SUBARU.

SERVICE BULLETIN

05-03-93

INFORMATION & INSTALLATION TIPS

Figure 1

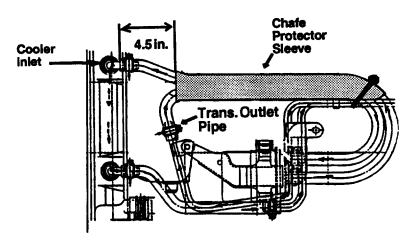
- 1. Always follow the complete instructions from Service Bulletin 16-51-92R, Dated 03-15-92.
- 2. Before installing the kit, make sure that the cooler lines from the transmission to the cooler are correctly installed. Hose routing can be identified by using Service Bulletin 16-53-92, Dated 07-09-92.
- 3. There have been several variations of filter kits available. All kits for Legacys are mutually interchangeable. However, to help minimize the possibility of the hoses being pinched or kinked which would cause a restricted fluid flow, make sure that both hoses that go to the cooler inlet and the transmission outlet pipe protrude at least 4 1/2" from the end of the chafe protector. See Figure 1 on the next page.

NOTE: You may have to trim the chafe protector back on the kits that have it glued to the hoses. Make sure you do not cut the hoses.

Only install the hoses far enough onto the pipe to assure a good seal from the hose clamp.
